SUBJECT: Forwards retyped Tech Spec pages, per 900910 application for amend to License NPF-63 re RCS pressure-temp limits.

SHEARON HARRIS NUCLEAR POWER PLANT
DOCKET NO. 50-400/LICENSE NO. NPF-63
RETYPE TECHNICAL SPECIFICATION PAGES
REACTOR COOLANT SYSTEM PRESSURE-TEMPERATURE LIMITS

SHEARON HARRIS NUCLEAR POWER PLANT
DOCKET NO. 50-400/LICENSE NO. NPF-63
RETYPE TECHNICAL SPECIFICATION PAGES

FIGURE 3.4-2

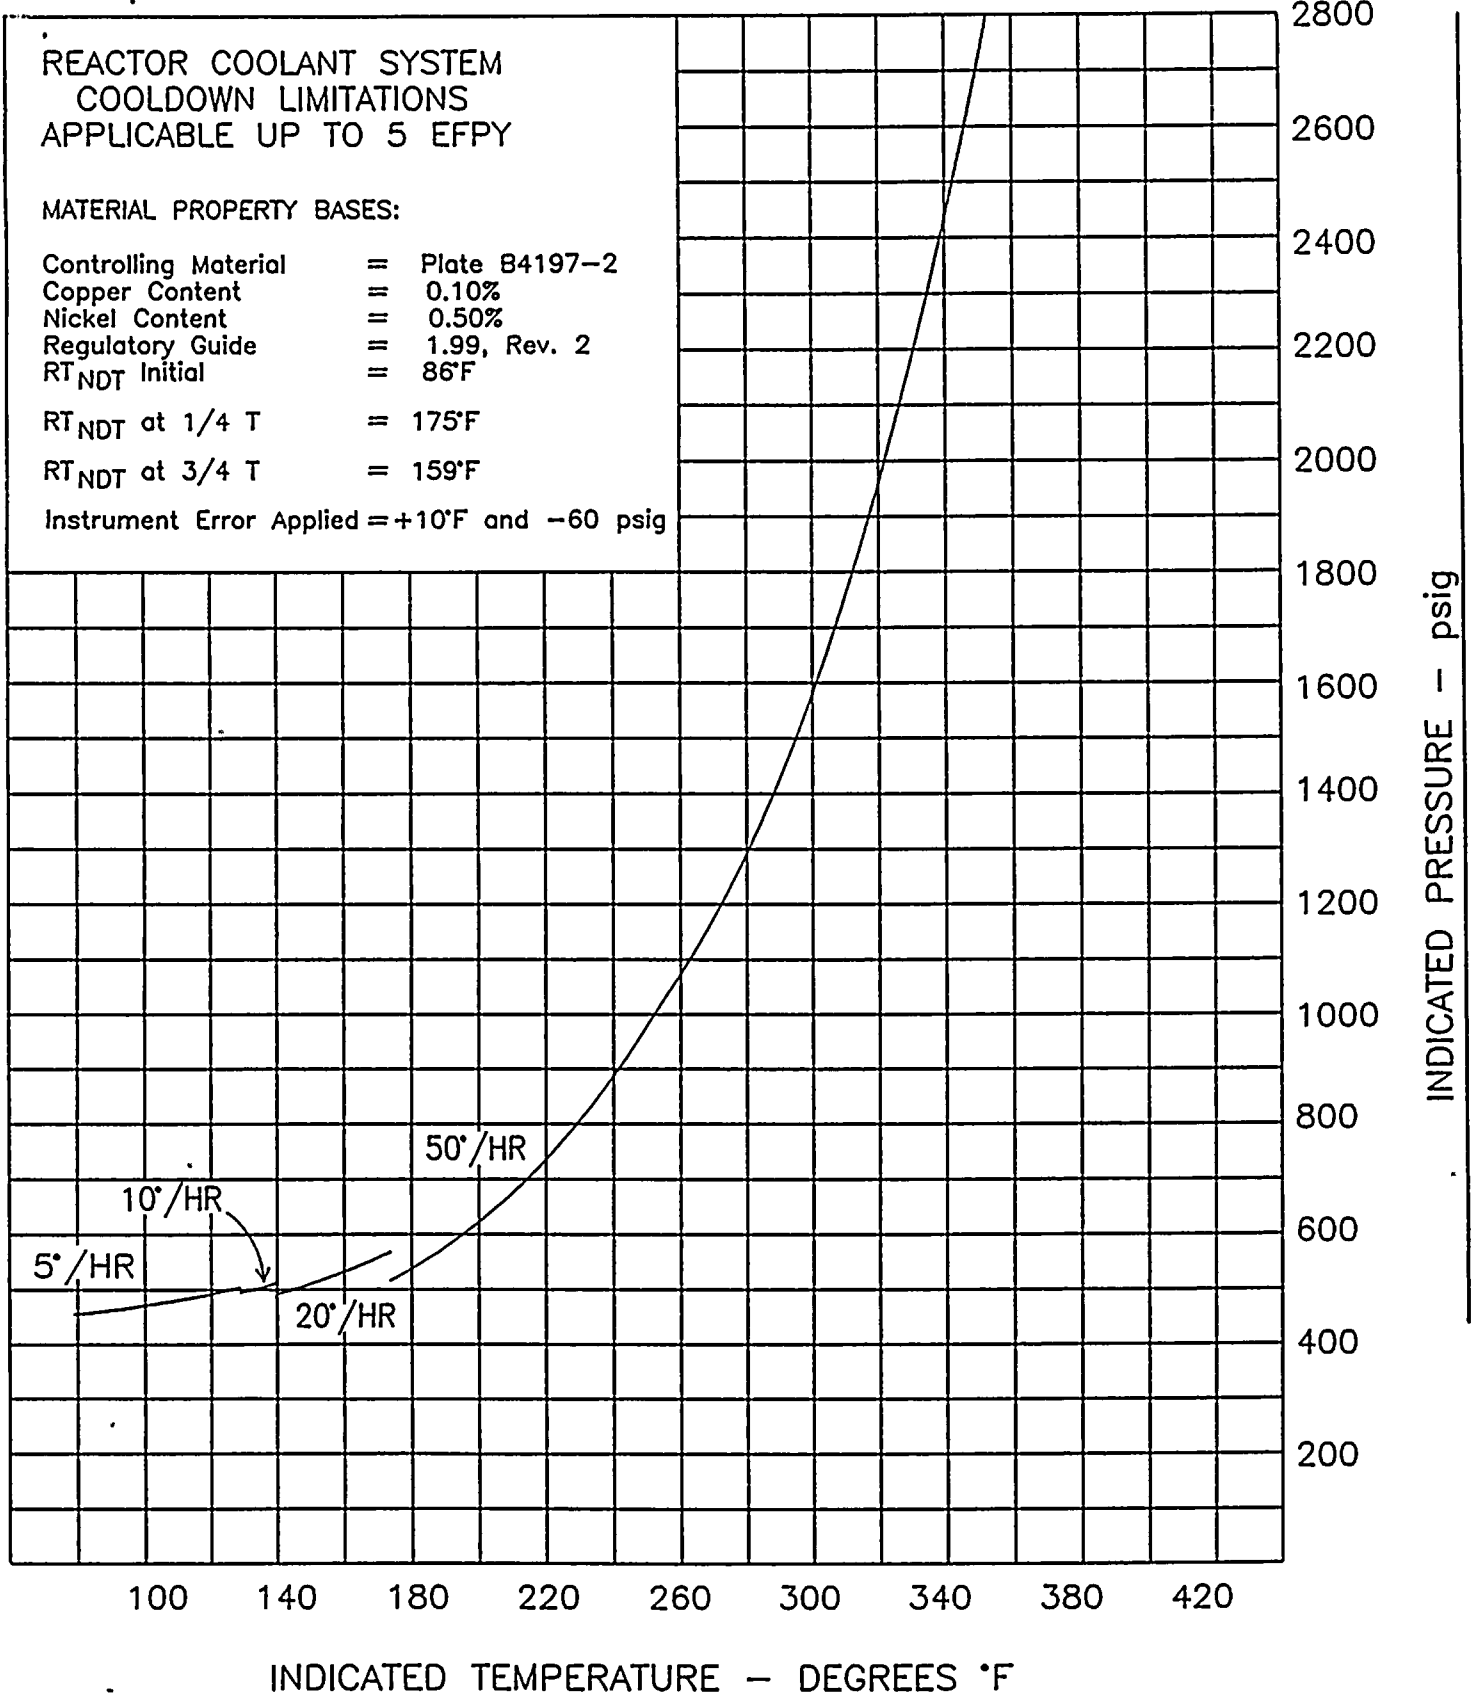
On September 10, 1990, Carolina Power & Light Company requested a License Amendment for the Shearon Harris Nuclear Power Plant, Unit 1, Technical Specifications concerning the Reactor Coolant System Pressure-Temperature Limits. This change revises the heatup and cooldown limitations of Specification 3/4.4.9. Enclosure 1 provides the retyped, amendment bar pages for your convenience in issuance of the proposed Technical Specification change.

Controlling Material = Plate B4197-2
 Copper Content = 0.10%
 Nickel Content = 0.50%
 Regulatory Guide = 1.99, Rev. 2
 RT_{NDT} Initial = 86°F
 RT_{NDT} at 1/4 T = 175°F
 RT_{NDT} at 3/4 T = 159°F
 Instrument Error Applied = +10°F and -60 psig

FIGURE 3.4-4

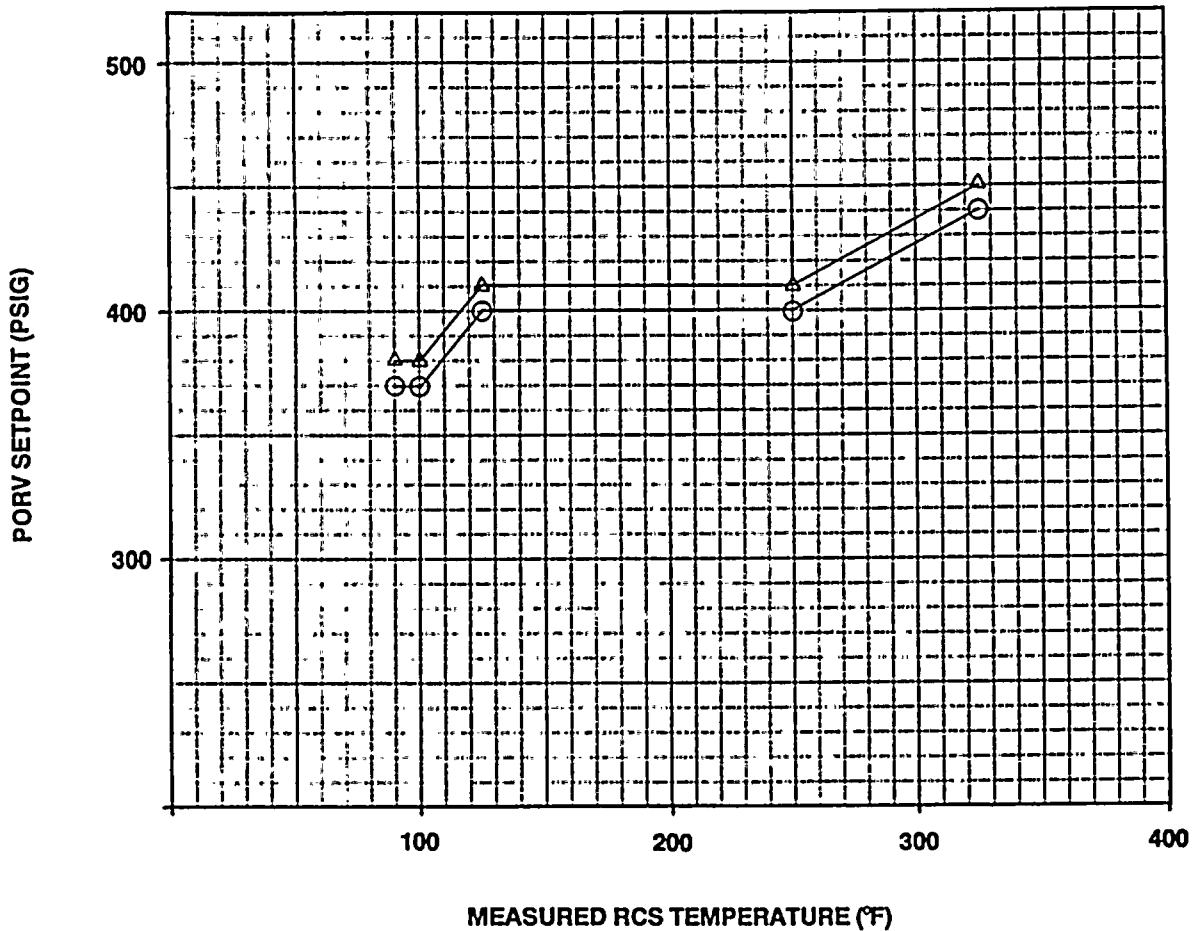
- a. The Reactor Coolant System (RCS) depressurized with an RCS vent of greater than or equal to 2.9 square inches, or
- * b. Two power-operated relief valves (PORVs) with setpoints which do not exceed the limits established in Figure 3.4-4.

| <u>RCS TEMP OF</u> | <u>LOW PORV * PSIG ○</u> | <u>HIGH PORV * PSIG △</u> |
| 90 | 370 | 380 |
| 100 | 370 | 380 |
| 125 | 400 | 410 |
| 250 | 400 | 410 |
| 300 | 427 | 437 |
| 325 | 440 | 450 |

* VALUES BASED ON 5 EPFY REACTOR VESSEL DATA AND
CONTAINS MARGINS OF -10°F AND +60 PSIG FOR POSSIBLE
INSTRUMENT ERROR
